COUNCIL ASSESSMENT REPORT

Panel Reference	PPSWC-14
DA Number	DA-257/2019
LGA	Liverpool City Council
Proposed Development	The demolition of existing structures, construction of a five (5) storey residential flat building comprising of 39 units with at-grade parking and associated landscape and site works to be used wholly for the purposes of affordable rental housing under State Environmental Planning Policy (Affordable Rental Housing) 2009.
Street Address	Lot 2 & 3 DP 373524 127 Flowerdale Road, Liverpool 2170
Applicant/Owner	SGCH PORTFOLIO LTD
Date of DA Lodgement	17 April 2019
Number of Submissions	Seven (7) submissions
Regional Development Criteria (Schedule 4A of the EP&A Act)	<p>The development contains affordable housing with a capital investment value of \$12,145,370.</p> <p>The proposal is for an affordable housing development that has a capital investment value of over \$5 million, the Sydney Western City Planning Panel is therefore the determining authority.</p>

Report date	24 January 2020

Figure 6: Extract of the floor plan that shown the extent of non-compliance with Building Separation on Level 4

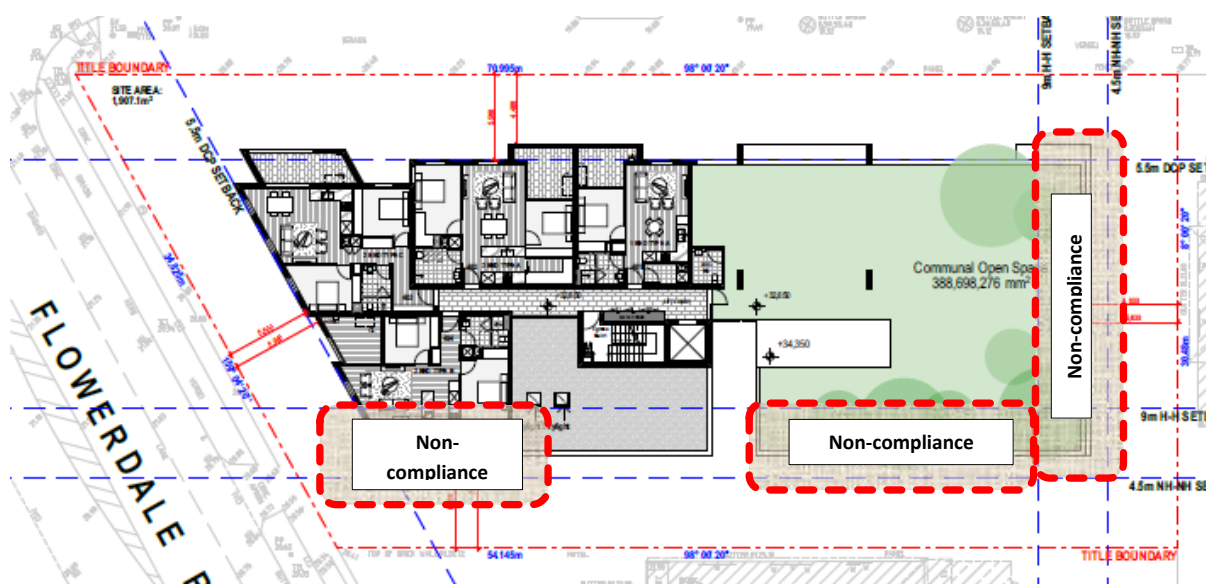
The proposed RFB contains windows to habitable rooms of dwellings on the southern elevation of Level 4. In this regard, a 9m building separation distance from the side property boundary is applicable. This application proposes a separation distance of 7m to the kitchen window and bedroom window of a dwelling. Furthermore, the applicant proposes a rooftop terrace on Level 4 that is less than 9m from the eastern property boundary and southern property boundary. The areas of non-compliance can be seen inb **Figure 6** below.

The applicant claims that, the proposed variation comes as a consequence of the SEPP ARH incentives. Considering this, reference is made to the aims in setting building separation controls so as to ensure that the overall development achieves high residential emnity of future occupants and surrounds. The proposed development is considered to be worthy of support for the following reasons:

Figure 7: – Extract of the section plan showing the building elements which exceed the height limit.

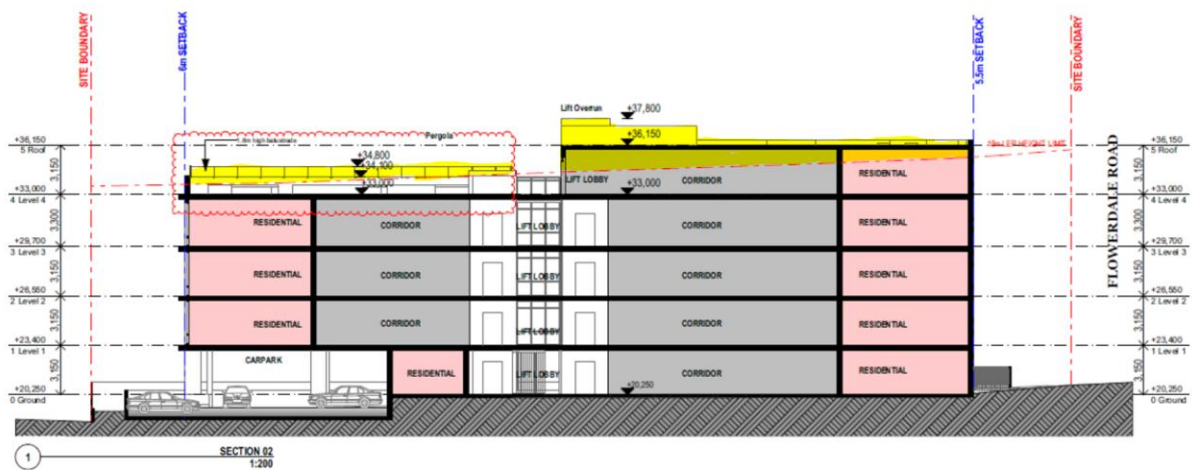
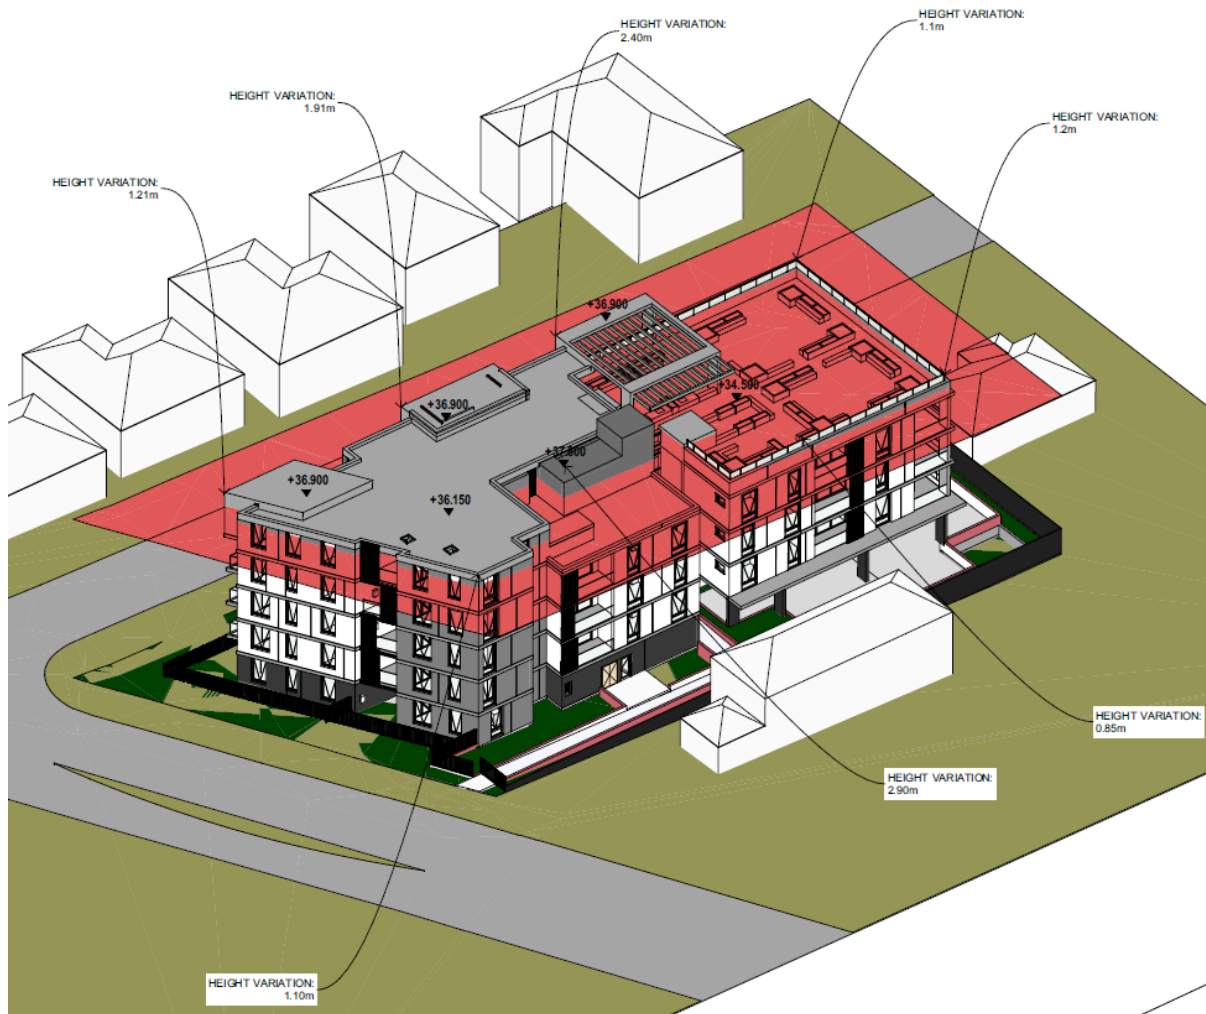
The current proposal seeks a maximum building height of 17.2m to the roof slab which represents a numerical variation of 2.2m or 14.6% and a maximum height of 18.1m to the lift overrun which represents a numerical variation of 3.1m or 20.6%. As demonstrated below, the non-compliance height relates Level 4 and the rooftop communal open space.

Consequently, the applicant has provided a clause 4.6 variation to justify the non-compliance. The submitted written request to vary Clause 4.3 - height of buildings has been assessed against the provisions of Clause 4.6; the objectives of the Clause being varied; and the objectives of the R4 zone. These are discussed below.

- The plans show that the bulk of Level 4 of the proposed development is confined to the north-eastern corner of the site, which is the highest point of the site. Therefore, the development has been designed so as to reduce the bulk adjoining existing residential properties to the south and east. As a result, the development minimises any additional length in shadow cast to adjoining neighbours to the south. Shadow diagrams have been submitted which shows that the impacts of the proposal to the southern neighbour is negligible compared to a complaint scheme. Also, it can be seen from the diagram that exceedance of the height limit as a result of the 1.8m high balustrade around the rooftop terrace does not result in additional shadow impacts as that part which exceeds the height limit is mainly comprised of glazing.

- The subject site accommodates a five storey building which is an anticipated built form in a zone that permits a height of buildings of 15m. The breach in height limit mainly stems from the topography of the site. In order to achieve a compliant building height, it would be necessary to remove the fifth storey of the building thereby reducing the dwelling yield of the development and possibly the amount of affordable housing onsite; or retaining the development yield but not without substantial changes to the building design which may result in an inferior design outcome. In this case, it is considered that there is adequate environmental grounds to support a variation.
